Addendum No. 01

Elevator Replacement
Western Reception, Diagnostic and Correctional Center
Jefferson City, MO
Project No: C2224-01

Bidders are hereby informed that the construction Plans and/or Specifications are modified as follows:

FLOOR PLAN - PENT
HOUSE
A10
1/4" = 1'-0"

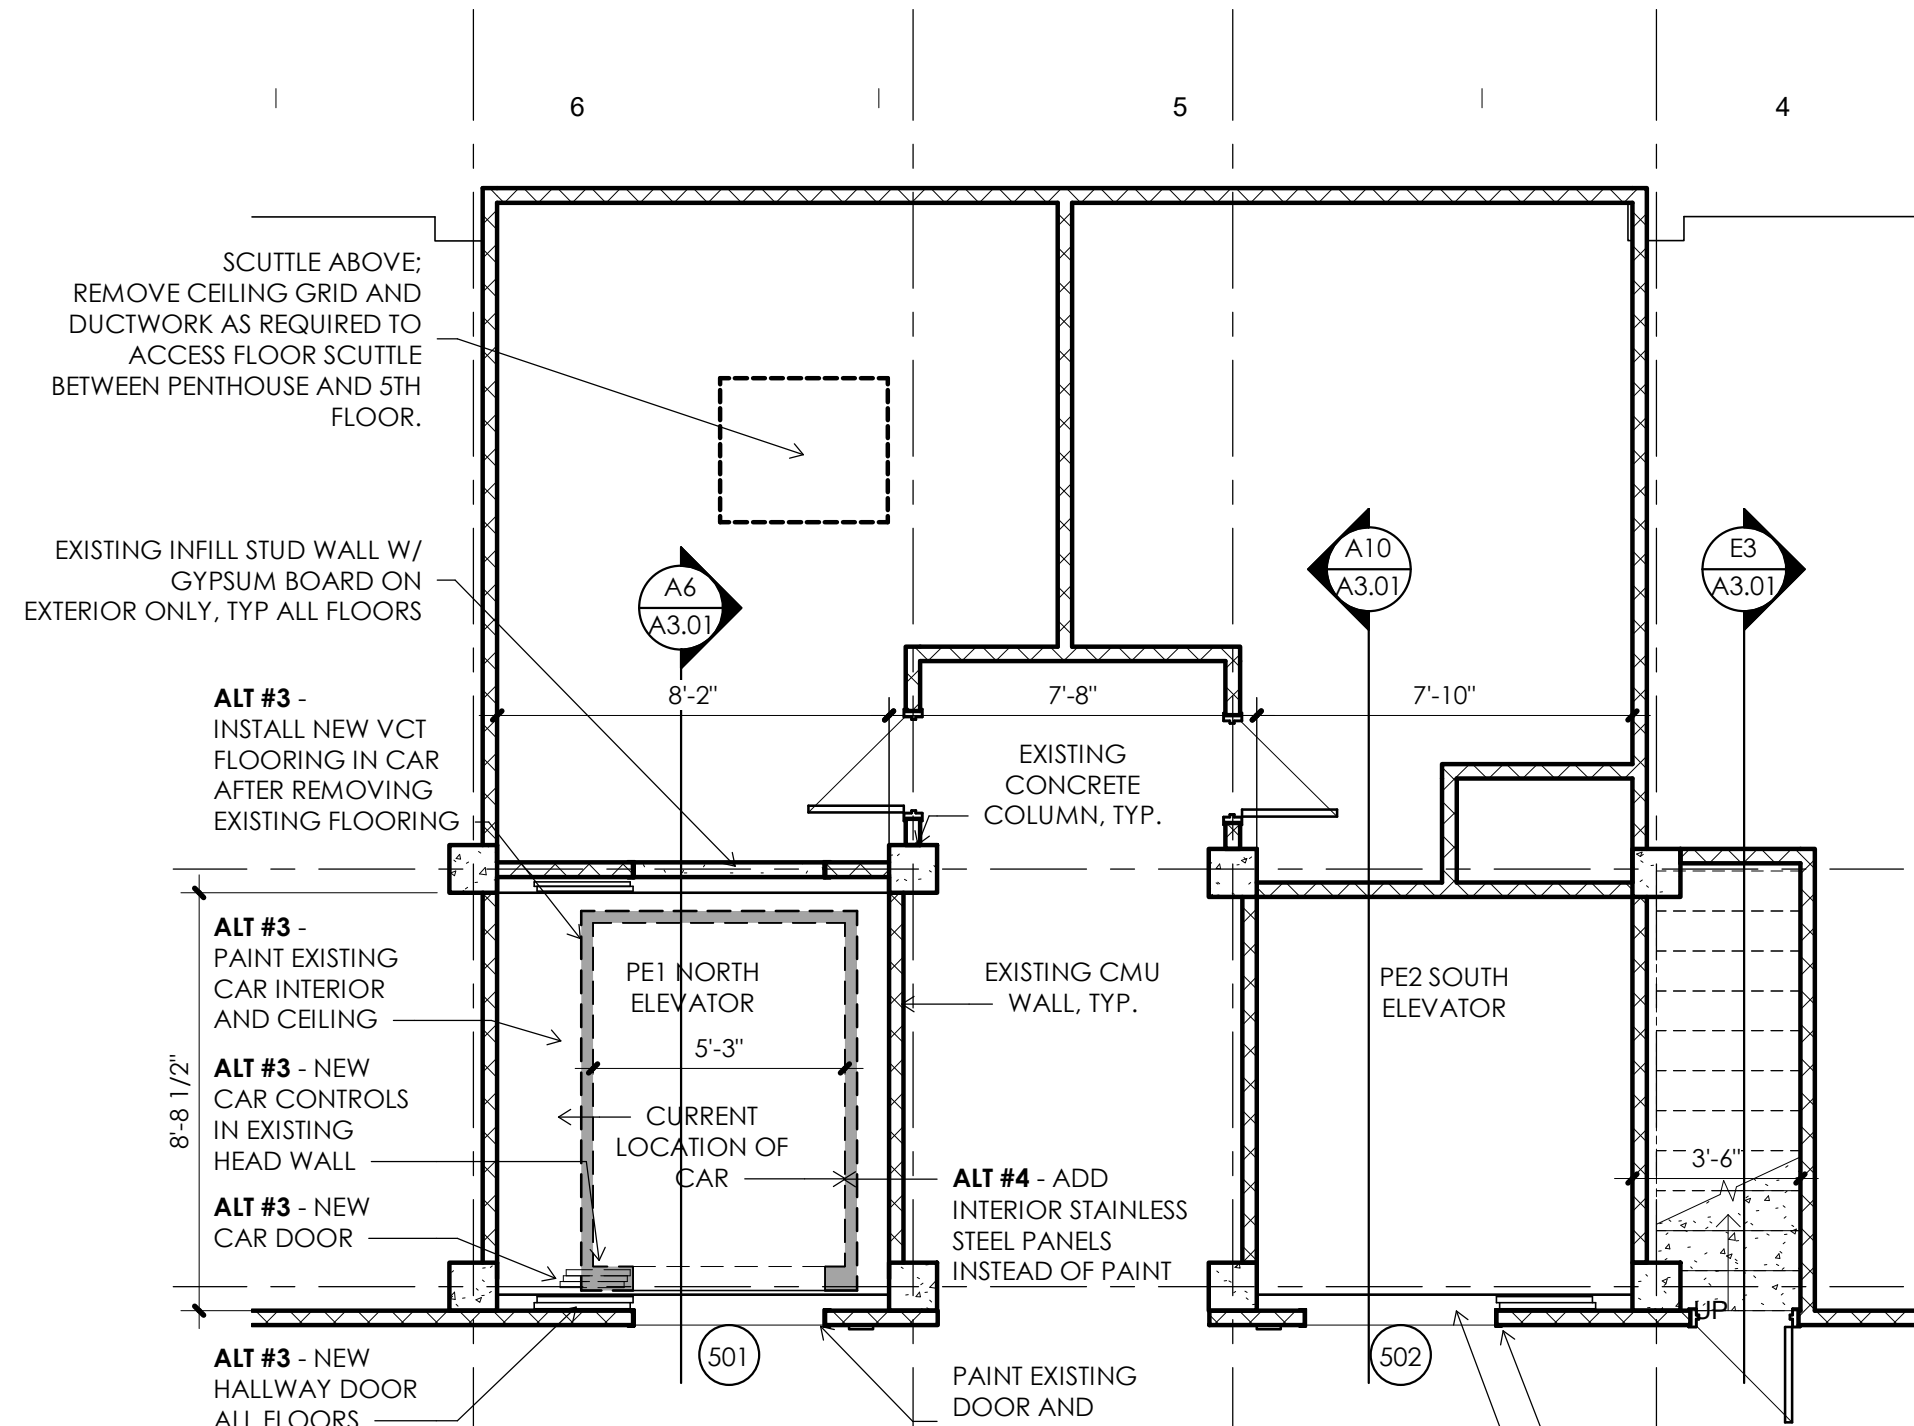
1. Drawing G1.00
 - a. REVISE detail A3 to show location of elevator lobby control panel as shown on revised sheet G1.00
2. Drawing A1.01
 - a. REVISE detail A10 to show location of new sheet metal shelf cap as shown on revised sheet A1.01
 - b. ADD detail E7 to show detail of 18 gauge metal closure as shown on revised sheet A1.01
